Amendment filed June 30, 2005  
Appln. No. 10/002,185  
Page 11

### **AMENDMENTS TO THE DRAWINGS**

The attached sheets of drawings include changes to Figs. 1, 2, and 3 and replace the original sheets including Figs. 1, 2, and 3.

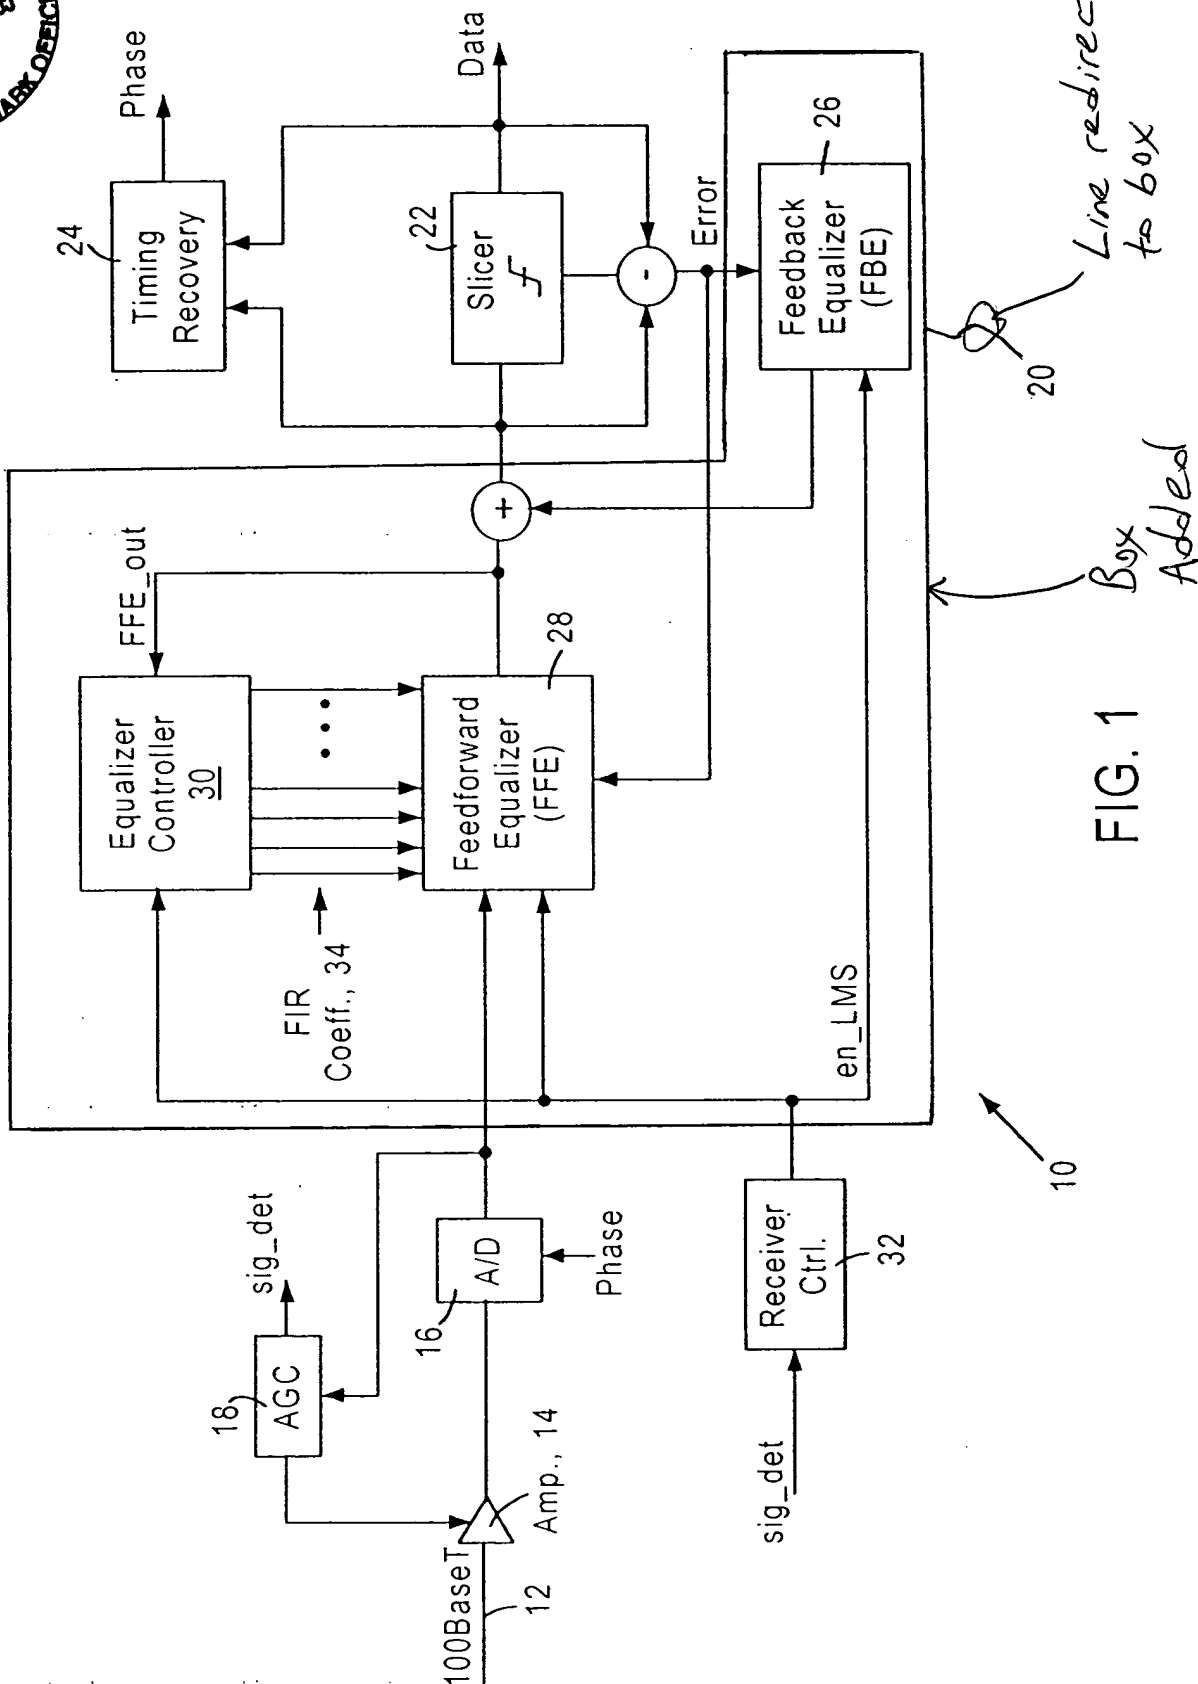
In Fig. 1, a box has been added to indicate that reference numeral 20 identifies the decision feedback equalizer circuit comprising elements 26, 28, 30 (see page 5, lines 28-29 of the specification).

FIG. 2

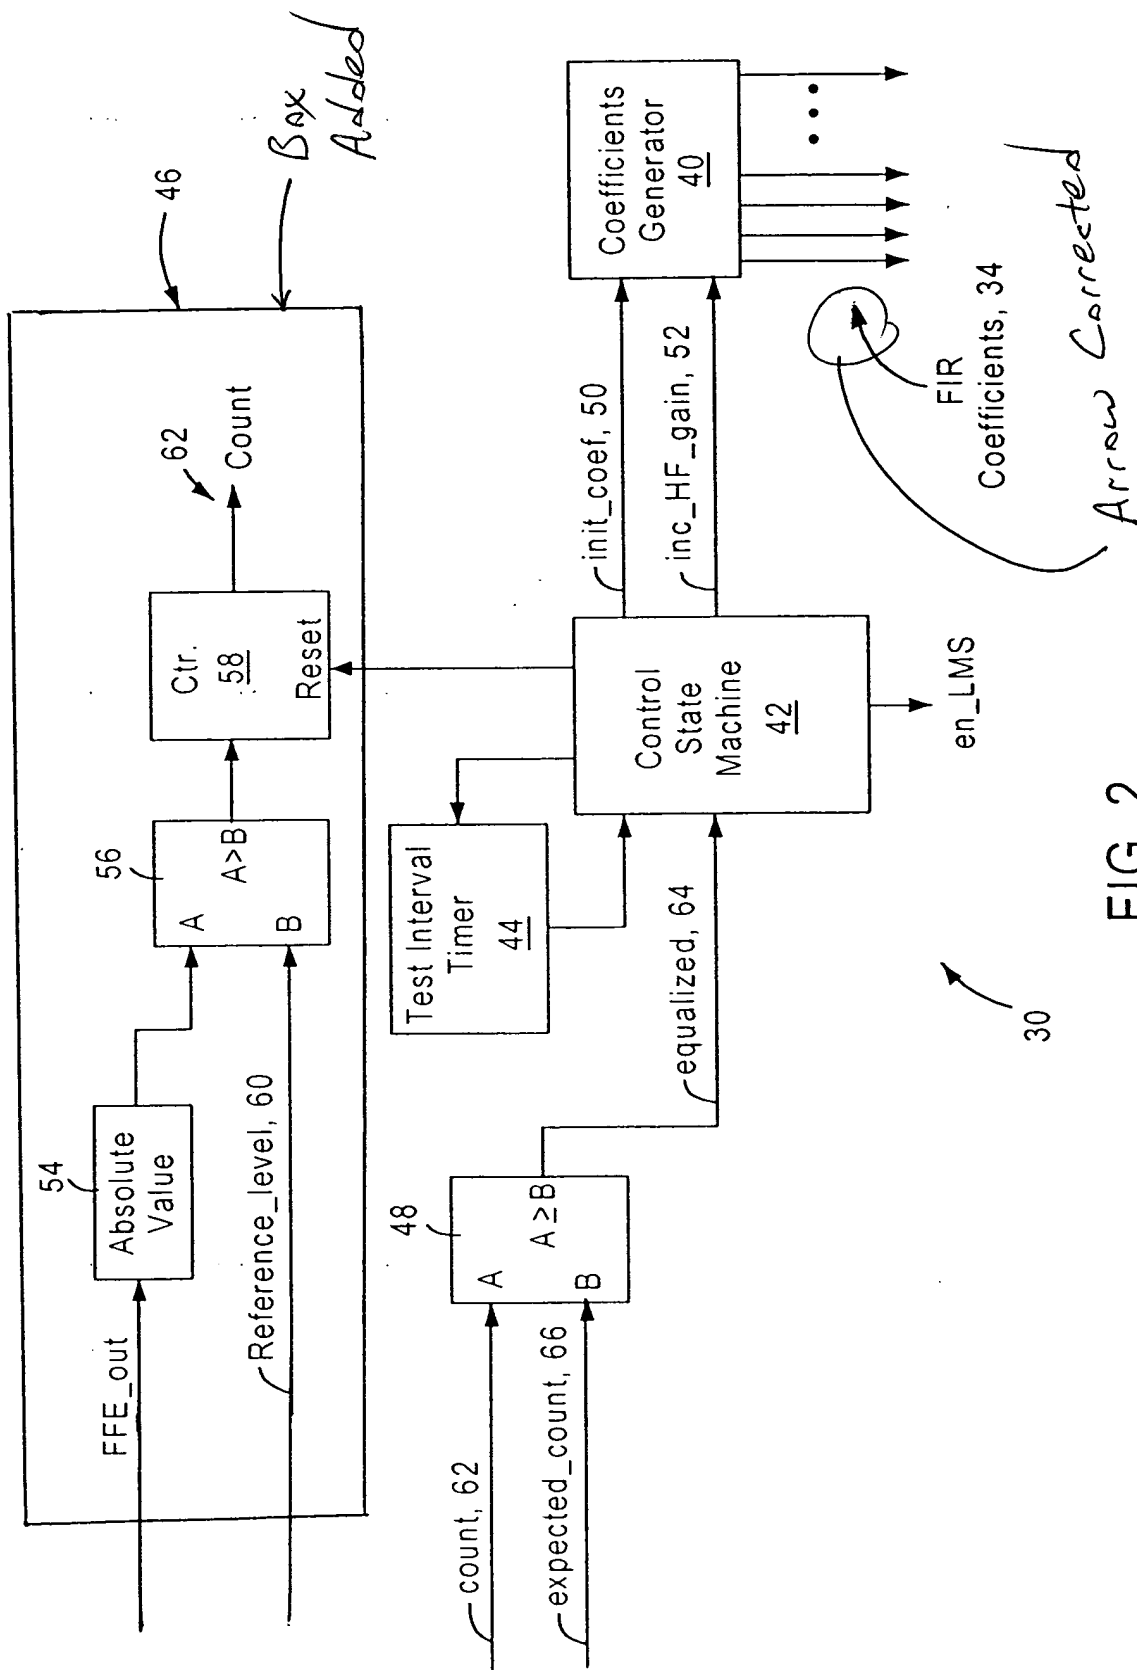
In Fig. 2, a box has been added to indicate that reference numeral 46 identifies the counter circuit comprising elements 54, 56, 58 (see page 7, line 12 of the specification), and the arrow for reference numeral 34 has been corrected.

FIG. 3

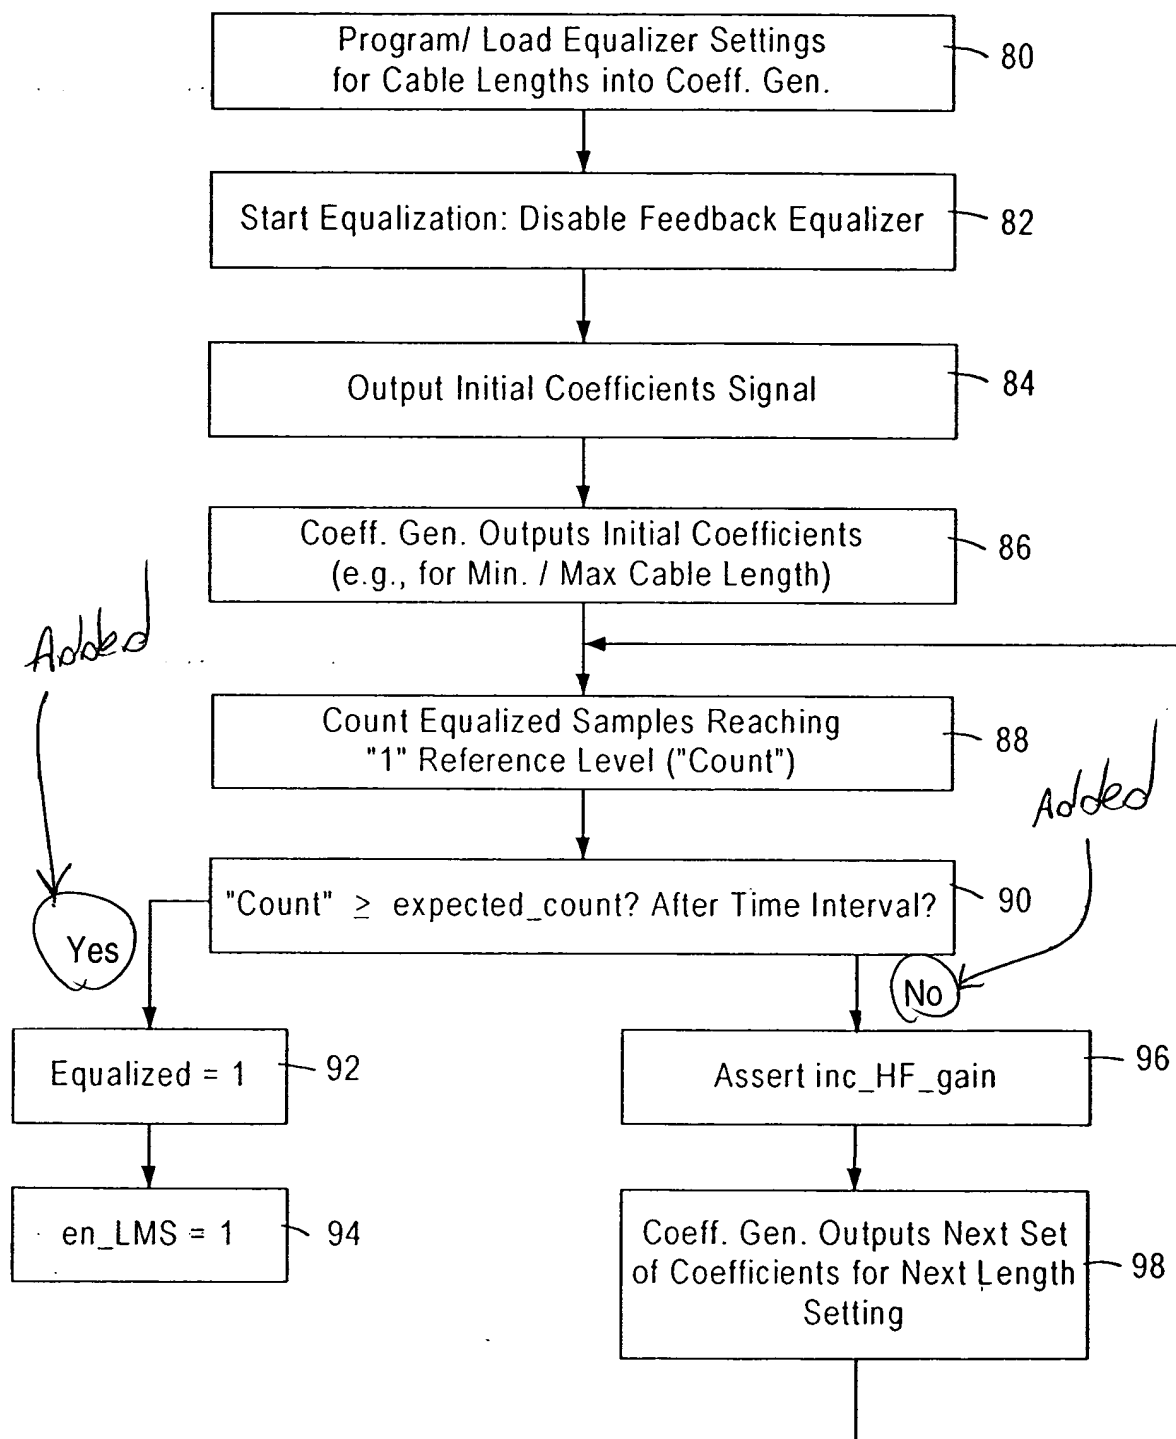
In Fig. 3, the decision labels "Yes" and "No" have been added with respect to step 90.
